PERMIT

SEWAGE DISPOSAL SYSTEM

SUBDIVISION _____ ROAD 13190 Folly Quarter Road _____ LOT _____

SEWAGE DISPOSAL TESTING

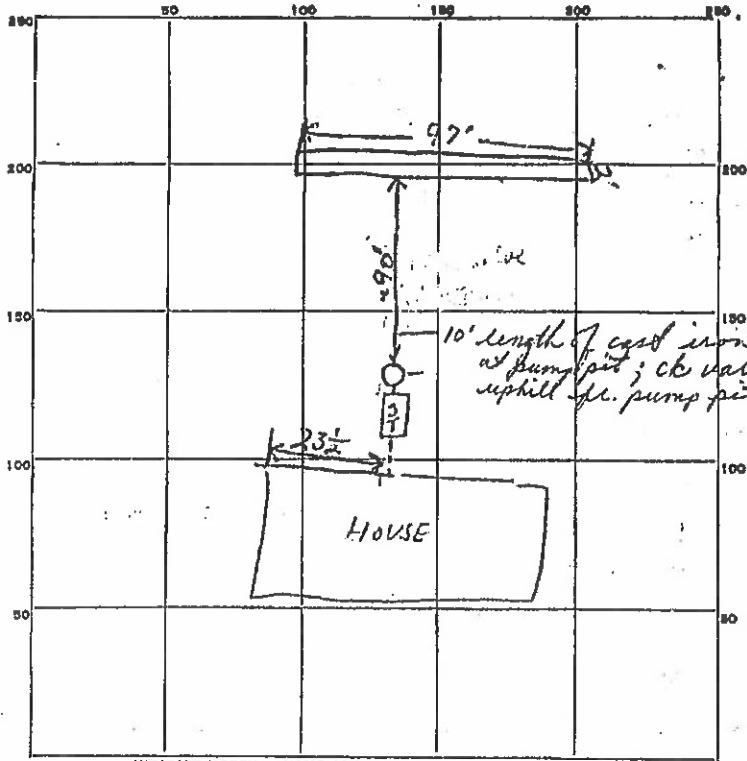
*As soon as possible
Need to see house -> ST conn. with*

*1/17/78 Installed, not approved. House to ST connection
not made or seen at final instpt. WWS.*

REMARKS 1/16/77, ① 3 well rings comprising pump pit. Electrical service present fr. house to pump pit. Trench depth 7-7 1/2' deep. W3+H3Z

② gravel to w/in 3' of surface. OK to cover.

4/27/83 System appears PVC pipe fr. pump pit uphill to trench. Need to OR report to see house -> ST conn. W3Z.

DATE SYSTEM APPROVED 4/27/83 INSPECTOR F. Skinn

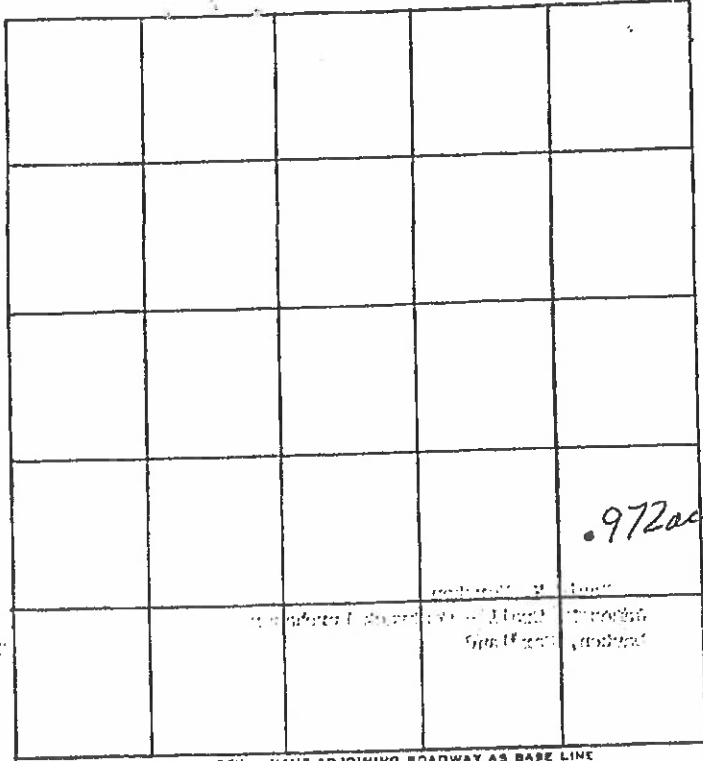
REMARKS FRONT RIGHT CORNER OF LOT IS 20 FT LOWER THAN BACK RIGHT CORNER AS SEEN WHEN FACING THE LOT FROM THE ROAD

REASONS FOR REJECTION OR HOLDING 7/30/75 Must Hold for Review Rock & Soil #
7/31/75 Hold for Review More Holes Needed 8/1/75 Hold for Review
